ACCESSION NBR: 8403130144 DOC. DATE: 84/03/02 NOTARIZED: NO DOCKET #  
 FACIL: 50-331 Duane Arnold Energy Center, Iowa Electric Light & Pow 05000331  
 AUTH. NAME: MCGAUGHY, R.W. AUTHOR AFFILIATION: Iowa Electric Light & Power Co.  
 RECIP. NAME: DENTON, H. RECIPIENT AFFILIATION: Office of Nuclear Reactor Regulation, Director

SUBJECT: Forwards response to NRC 840207 request for addl info re plant unique analysis rept for Mdark I torus mods.

Subject: Duane Arnold Energy Center  
Docket No: 50-331  
Op. License No: DPR-49  
Mark I Torus Modifications  
Reference: NRC Letter, D. Vassallo to L. Liu, dated  
February 7, 1984

Attachment: Response to NRC Request for Additional Information  
Regarding Mark I Containment Plant Unique Analysis Report

FIGURE 3-1

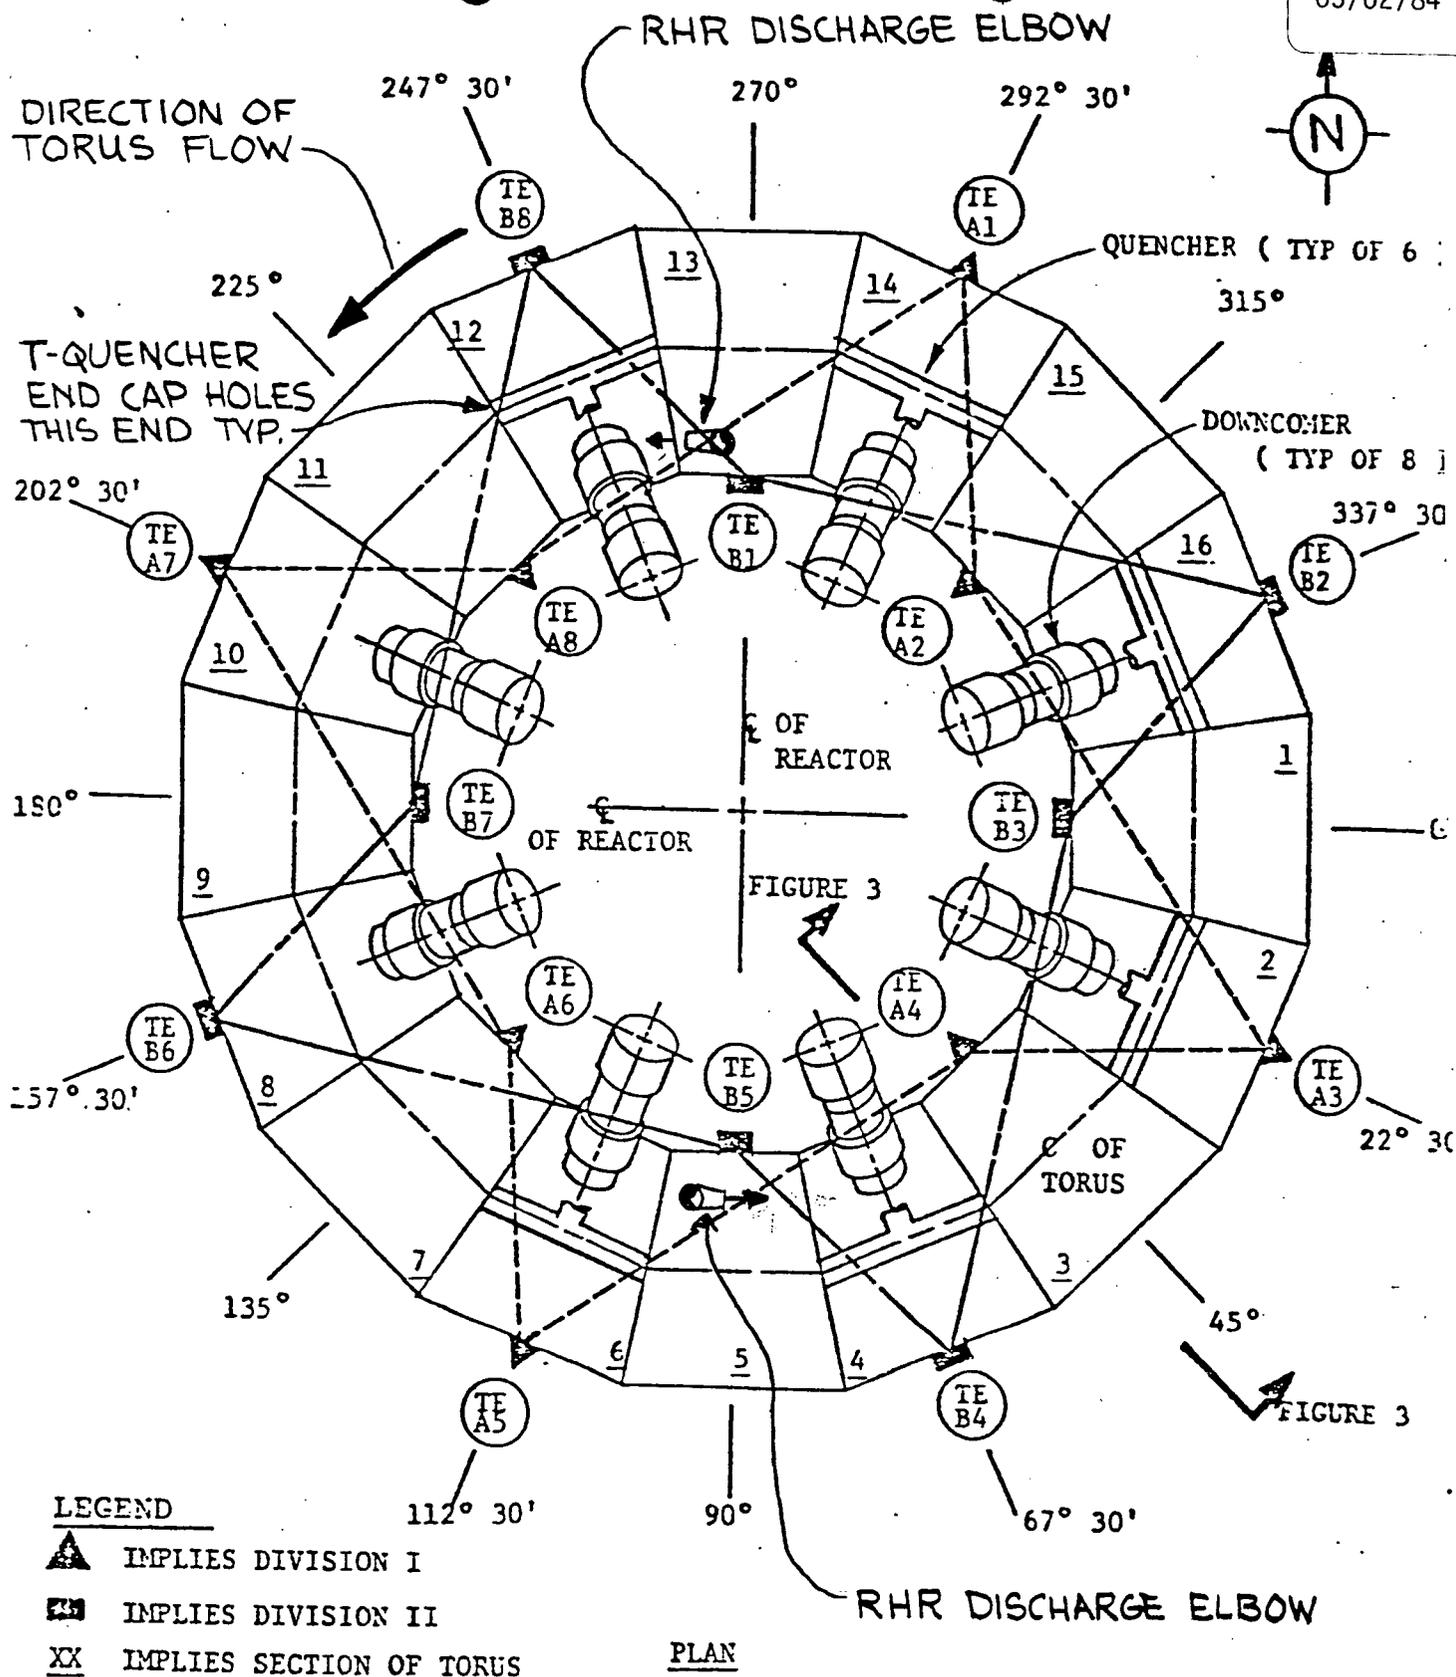
- a) A sketch which shows the circumferential locations of the sensors with respect to the T-quencher locations in a plan view such as Figure 1-2.1-5.

Item 3: b) In addition, indicate on this sketch, the direction of the RHR nozzle discharges and the T-quencher arms which have end cap holes.

Response: The attached Bechtel drawing (Figure 3-1) shows the circumferential location of both trains of SPTMS Temperature Sensors in relation to the six T-quenchers.

Response: Superimposed on the attached Bechtel drawing is the location of the two RHR discharge nozzles and a note identifying the hole end of the T-quenchers.

Figure 4-1  
STRAIN GAGE LOCATIONS ON THE SRV PIPING, ELBOW  
SUPPORT BEAM, AND VENT HEADER SUPPORT  
COLUMNS IN THE TEST BAY

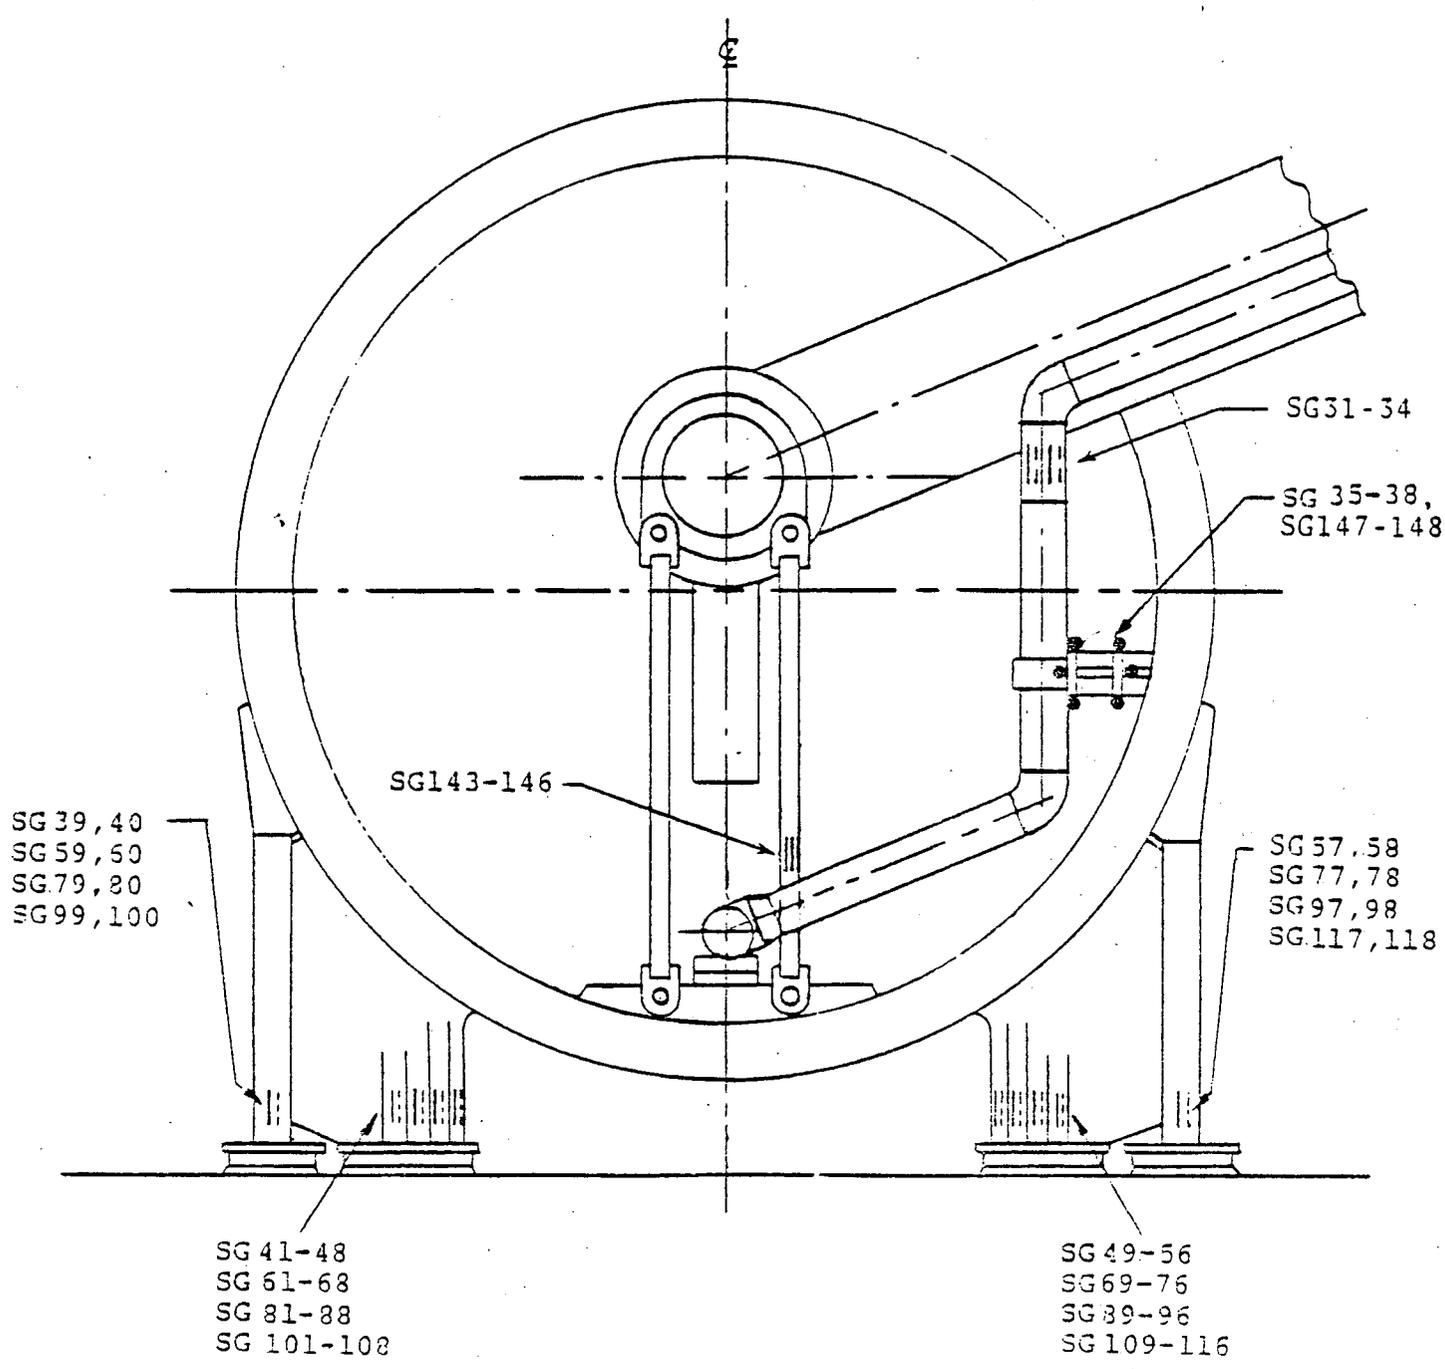
Item 4(c): Describe in detail how the calibration factors (page 1-4.103) were developed from the in-plant tests conducted at DAEC for use in the determination of the drag loads on SRV lines, elbow support beams, T-quenchers and their supports, and vent header support columns. Include as part of your response, the various test data, instrumentation layout with respect to quencher location, etc. used to derive the factors. Justify the use of these factors for the design SRV discharge event cases.

Location and orientation of strain-gages used in the derivation of calibration factors for SRV line (strain gages 31-34), elbow support beam (strain gages 35-38 and 147-148), and vent header support columns (strain gages 143-146) are shown in the attached Figure 4-1. The pressure transducers  $P_1$  through  $P_4$  on the quencher are shown in the attached Figure 4-2. Typical strain time histories measured in the in-plant test are shown in Figures 4-3 and 4-4.
